**Fw: Columbus US Courthouse and Post Office Security Renovation -
On-Street Parking**

Subject: Columbus US Courthouse and Post Office Security Renovation - On-Street Parking

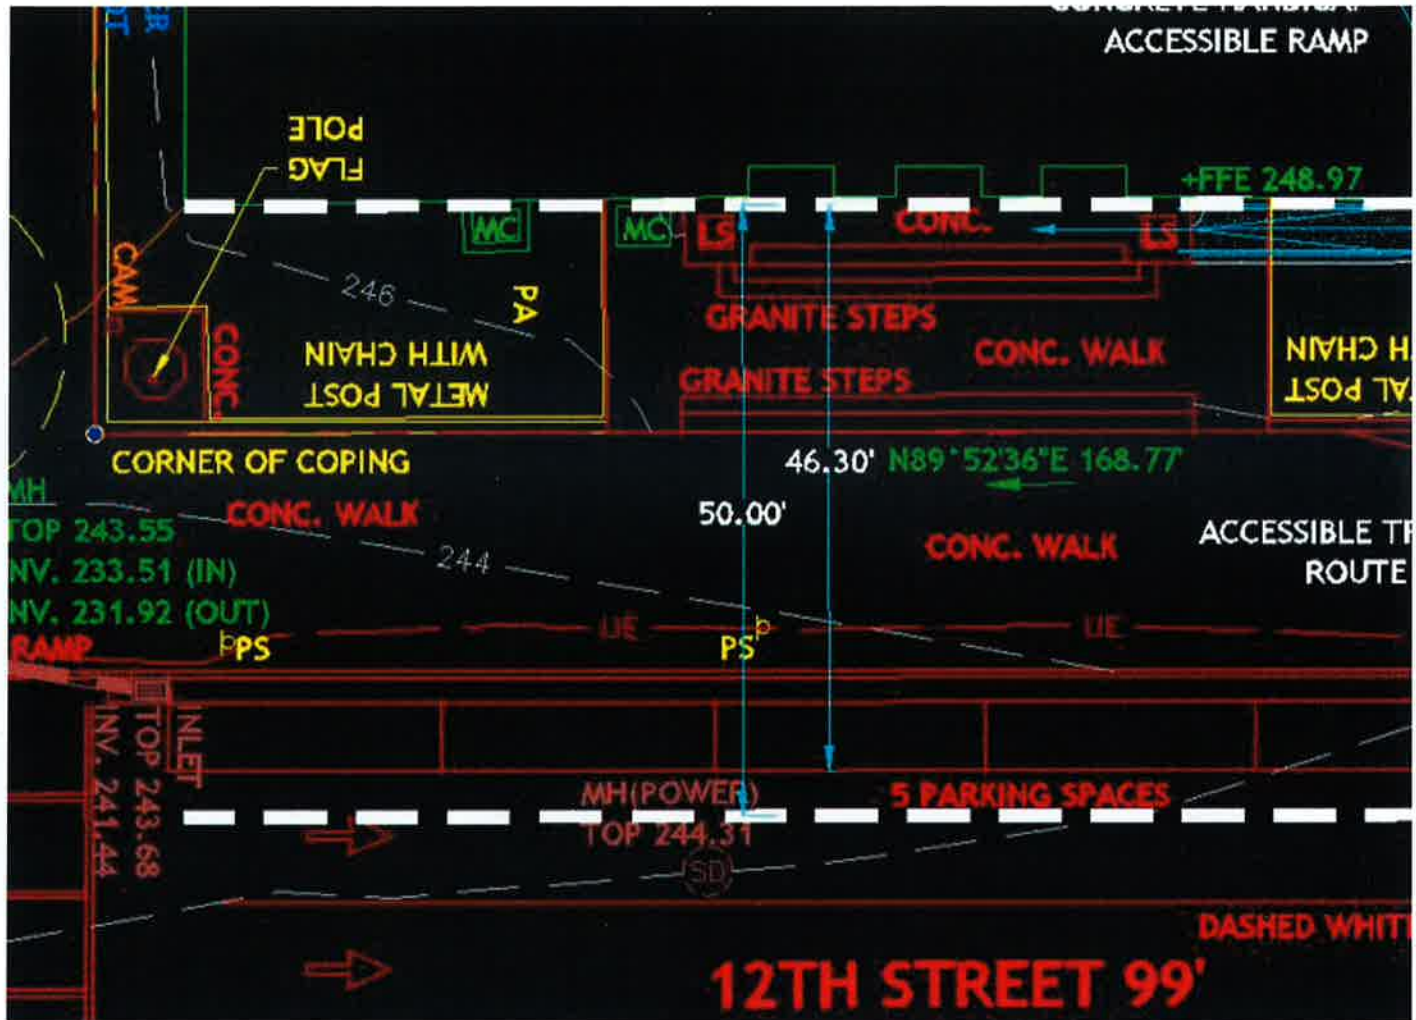
I wanted to follow up with you regarding the Columbus US Courthouse and Post Office Security Renovation regarding the on street parking existing on 12th Street. It is the US Marshal's Service request to inquire on the possibility of the removal of the on street parking along the frontage of the Courthouse on 12th Street. Please see the quick screenshot of the area.

Per USMS security requirements, the distance from building face to face of curb shall be 50'. The requirement of 50' is not obtainable because it would encroach on the nearest travel lane, however with the removal of the on-street parking a distance of approximately 46' can be provided. The area of the existing parking spaces would be replaced with a new curb and landscape island to prevent any parking or drop off directly in front of the Courthouse. Currently the parking in this area is 15. Min. maximum parking spaces for the courthouse.

Please proceed with removal of parking in front of US Courthouse council documents.

Yes. He said to give them what they asked for, no parking in front of Courthouse (5 spaces).
